GE Nuclear Energy

April 16, 1996

MFN 050-96
Docket No. 52-001

ABWR Design Change Assessment Review of FOAKE Design Changes

FIGURE 9.2-1 REACTOR BUILDING COOLING WATER SYSTEM P&ID (Sheet 3 of 9)
 ABWR DCD/Tier 2 Rev 0 21-510

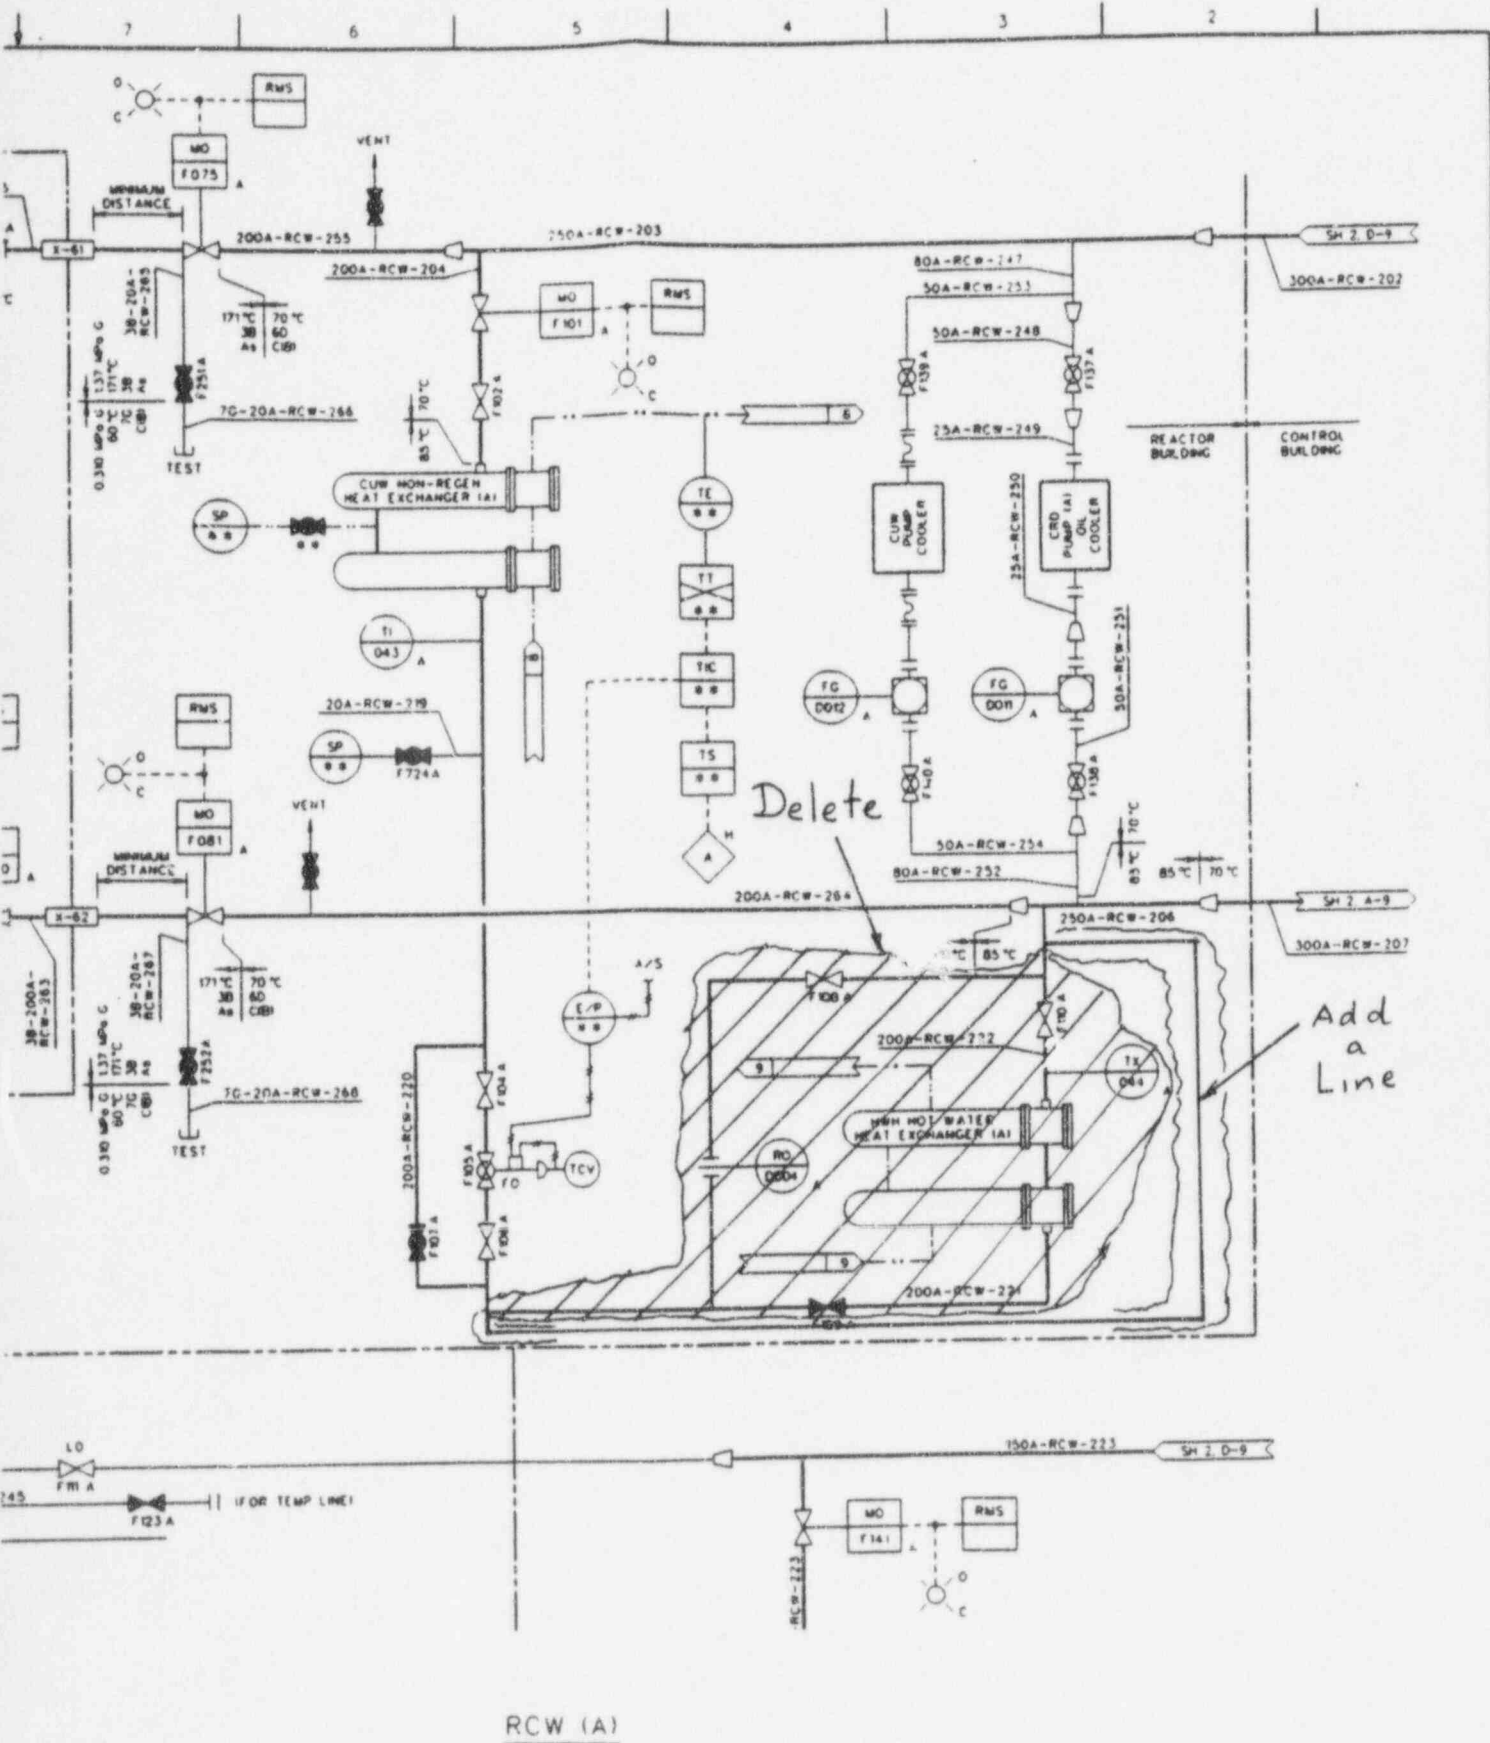
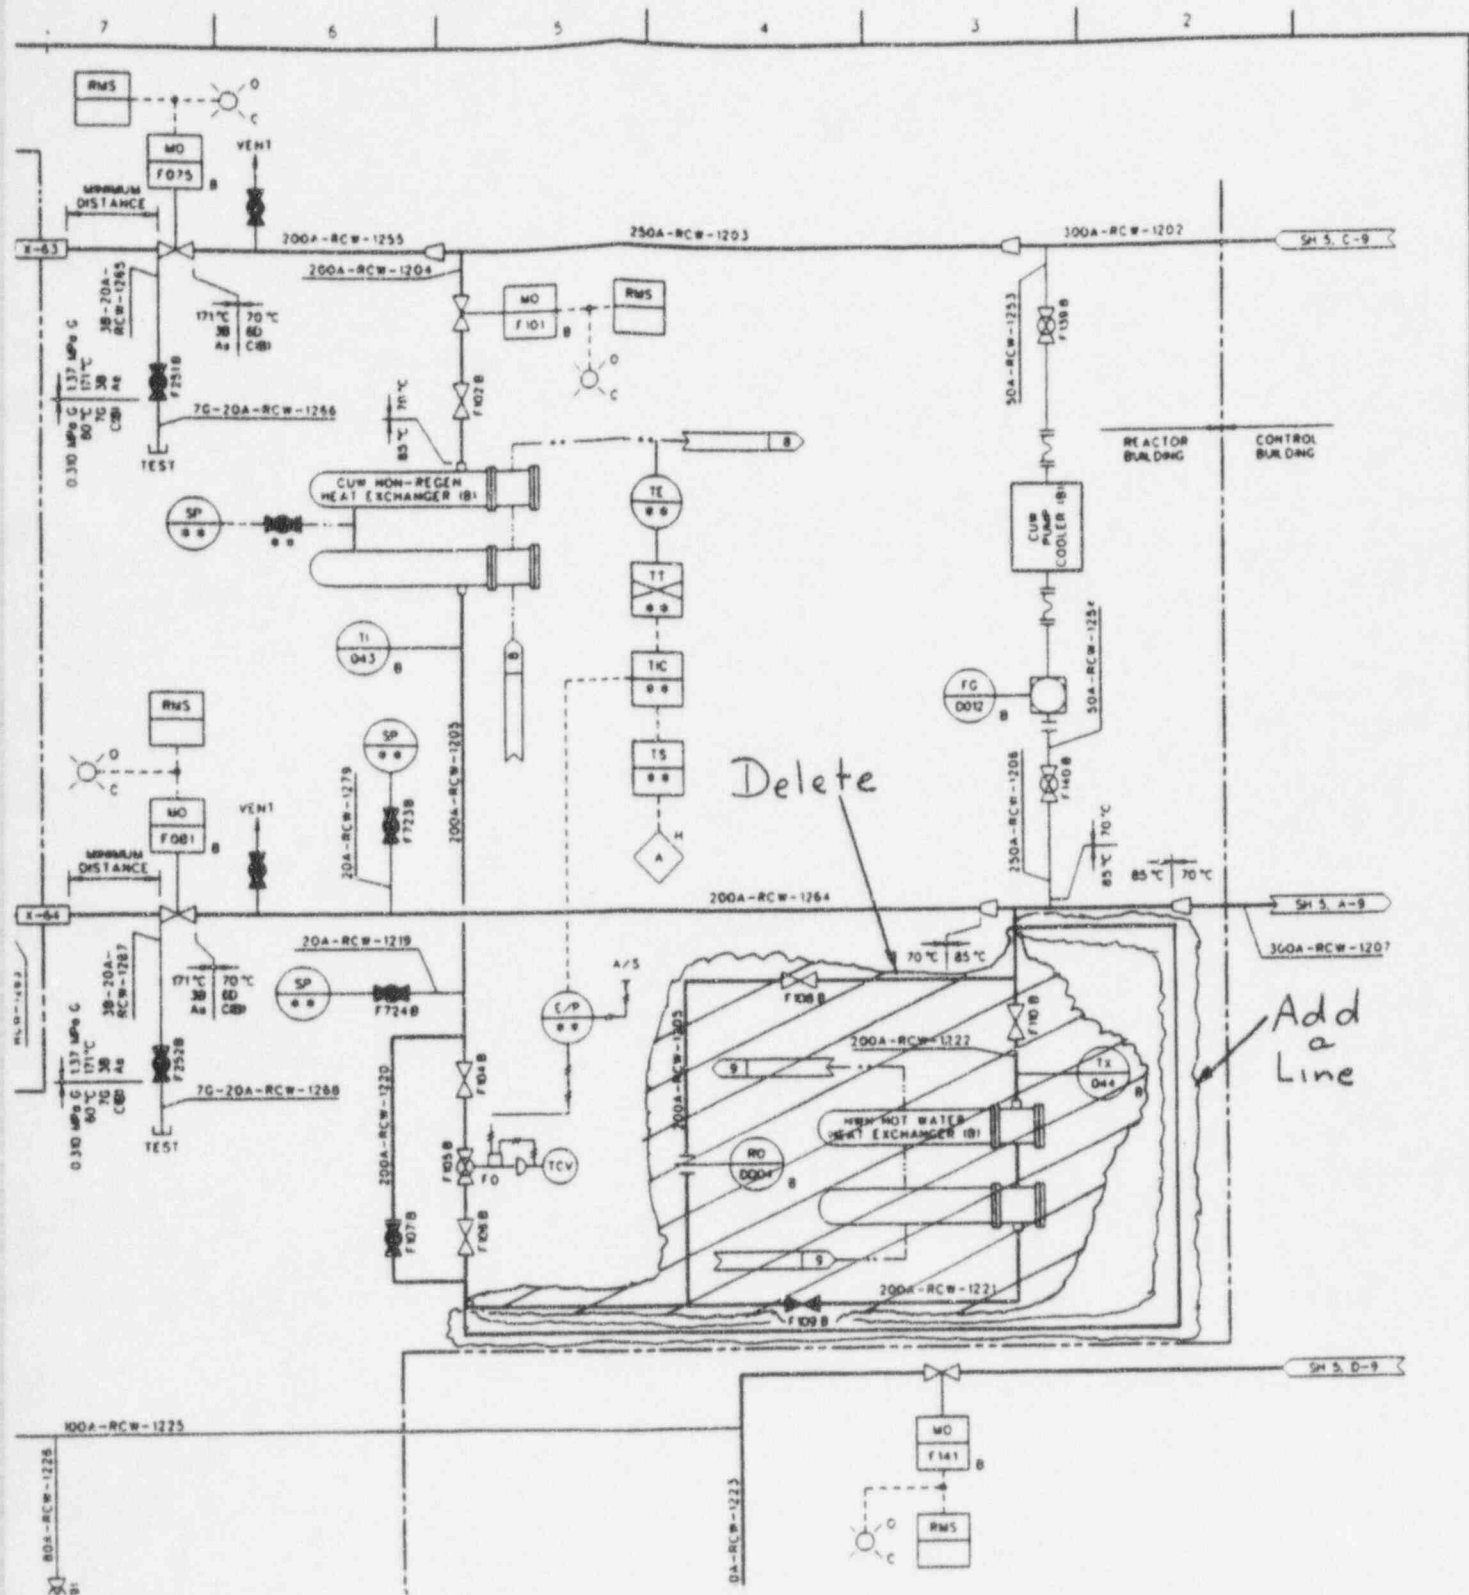
**Eliminate Hot Water Heating
for RB and RWB HVAC**

†† Instruments and service air coolers; CUW pump cooler, CRD pump oil, and RIP MG sets. ~~A hot water exchanger is in this division which removes heat from the RCW System.~~

FIGURE 9.4-3 SECONDARY CONTAINMENT HVAC SYSTEM (Sheet 1 of 3)
 ABWR DCD/Tier 2 Rev. 0 21-542.1

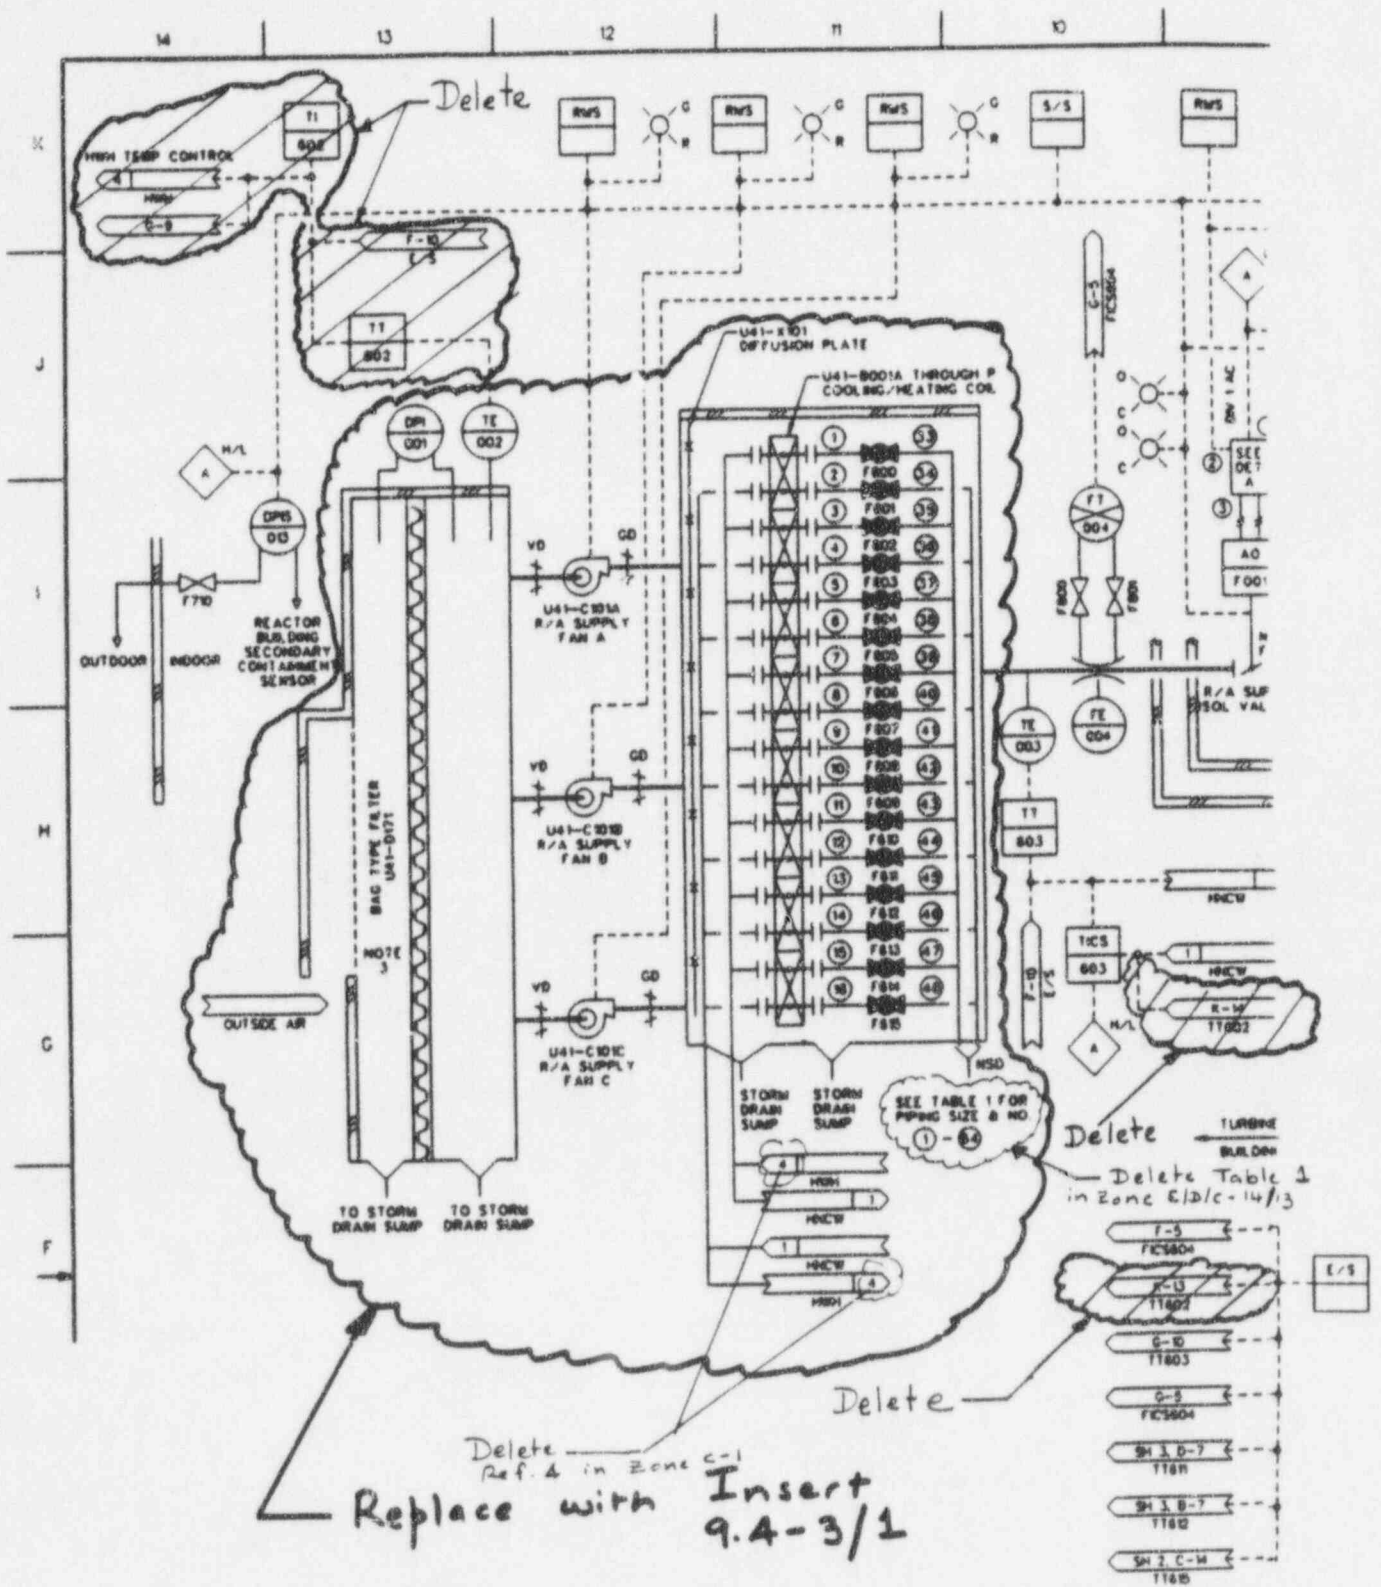
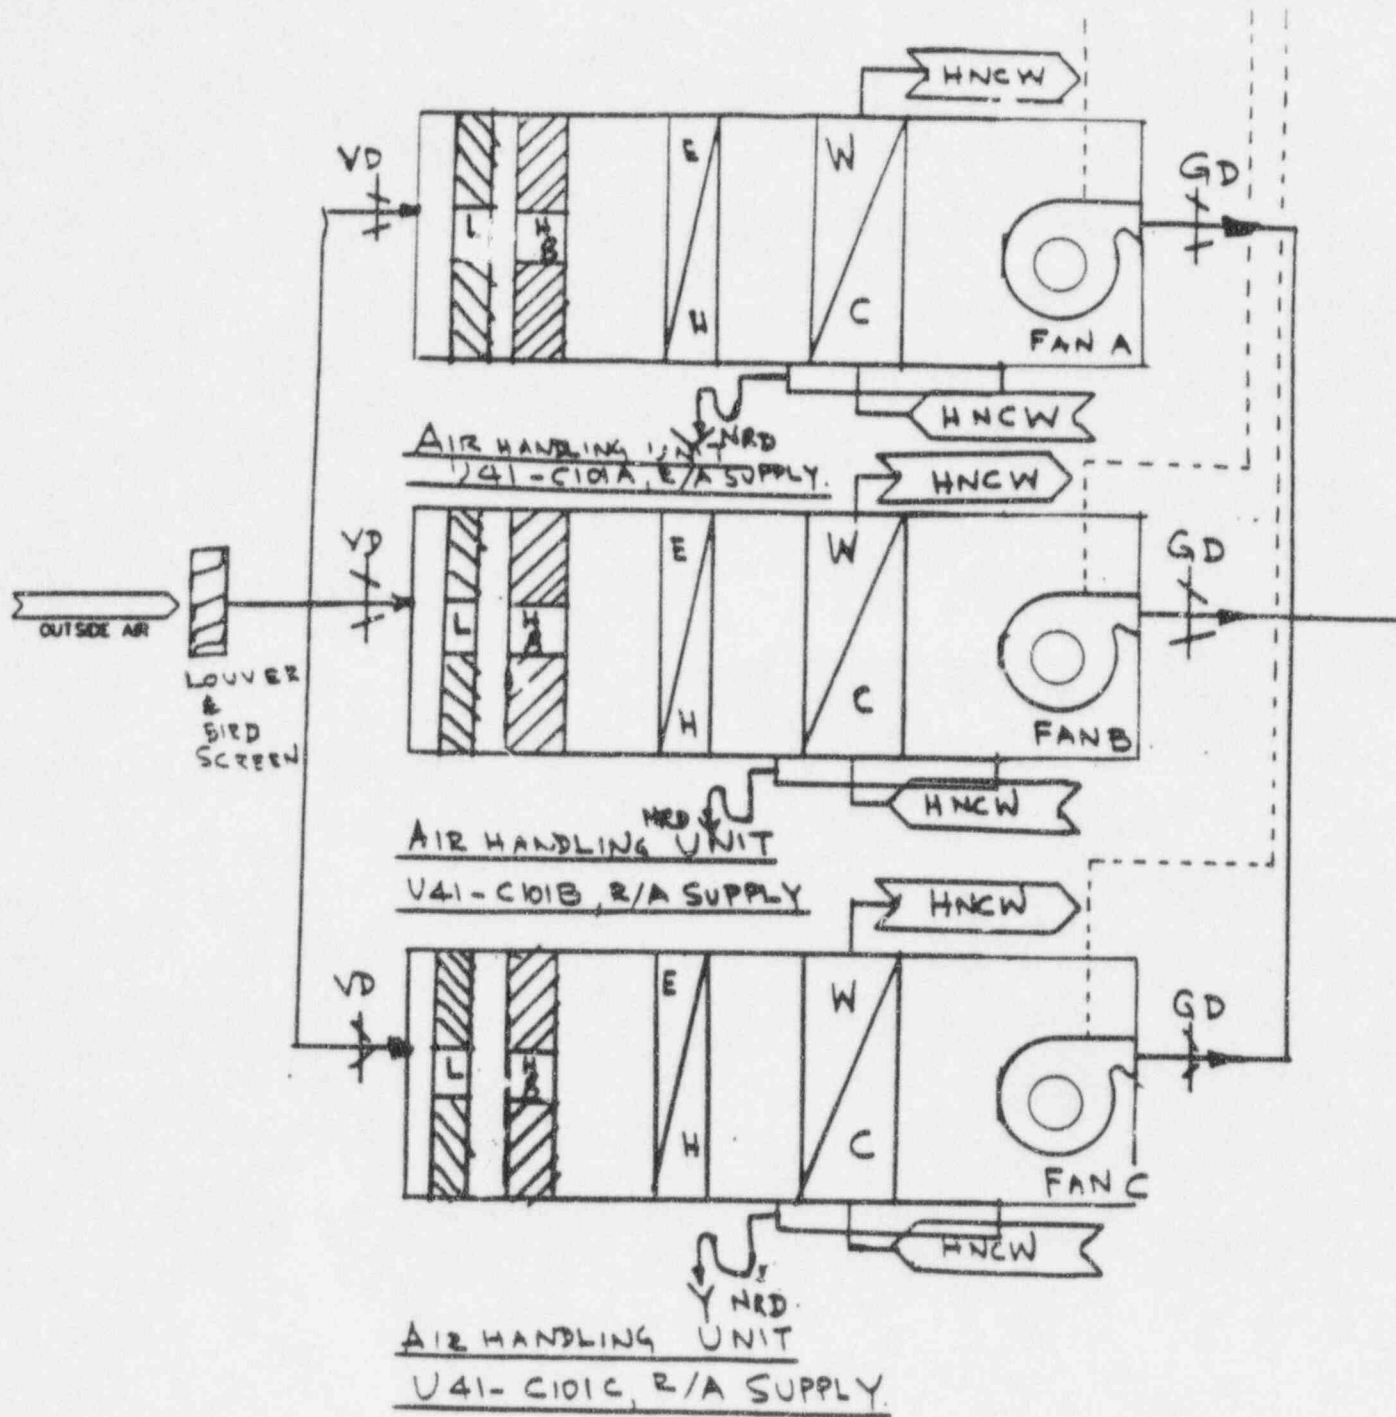
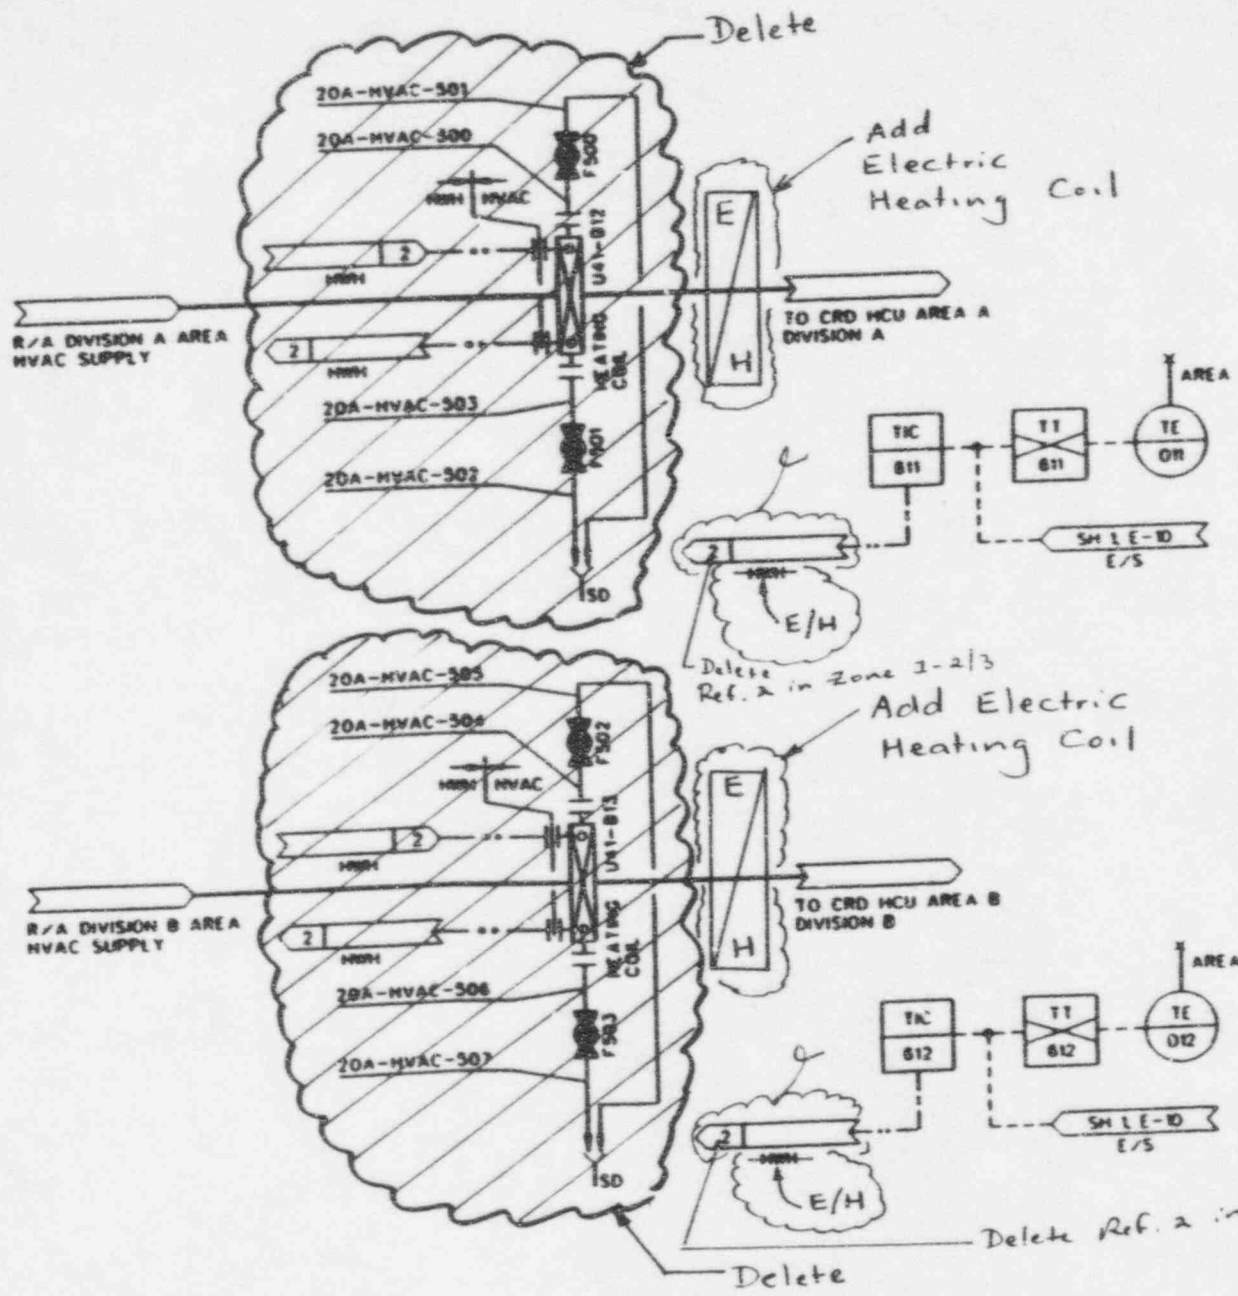
Heating/Cooling Coils	Quantity	Cooling (MJ/h)	Heating (MJ/h)
R/B Secondary Containment HVAC	1 ^{Replace with "3 (1 on standby)"}	6435.95	9601.17
RIP ASD HVAC Division A	1	2110.15	
RIP ASD HVAC Division B	1	2110.15
